NUMBER: 23-022-06

GROUP: Body

Whistle-Like Sound Due To Cabin Air Passing Through The Sunroof Front Drain Tube

2006 (XK/XH) Commander

819982cb

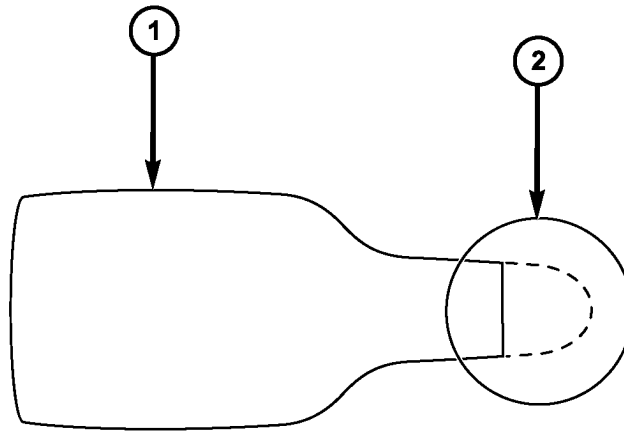
Fig. 1 END CAP WITH 8 MM REMOVED

- 1 - Plastic End Cap
- 2 - Remove 8 mm (5/16 inch) Of Material From The Tip Of The End Cap

-
1. Trim **8 mm (5/16 in.)** of material from the tip of the new cap. This will create a drain hole in the cap ([Fig. 1](#)).
 2. Remove the front door sill scuff plate.
 3. Remove the lower A-Pillar cowl (kick) panel. Refer to the detailed service information available in TechCONNECT, under: Service Info > 23 - Body > Interior > Cowl Trim > Removal and Installation.
 4. Remove the molded end grommet of the sunroof front drain tube from the vehicle body.
 5. Slide the new modified cap over the molded end grommet of the drain tube ([Fig. 2](#)).

819982cc

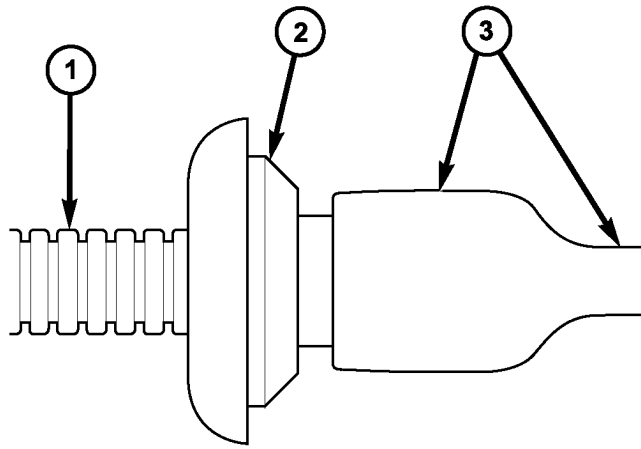
Fig. 2 DRAIN TUBE GROMMET WITH CAP

- 1 - Sunroof Front Drain Tube Hose
- 2 - Front Drain Tube Hose Molded End Grommet
- 3 - New End Cap Installed Over Molded End Grommet

6. Install the molded end grommet of the drain tube to the vehicle body.

NOTE: Verify that the drain tube end grommet is FULLY seated to the body.
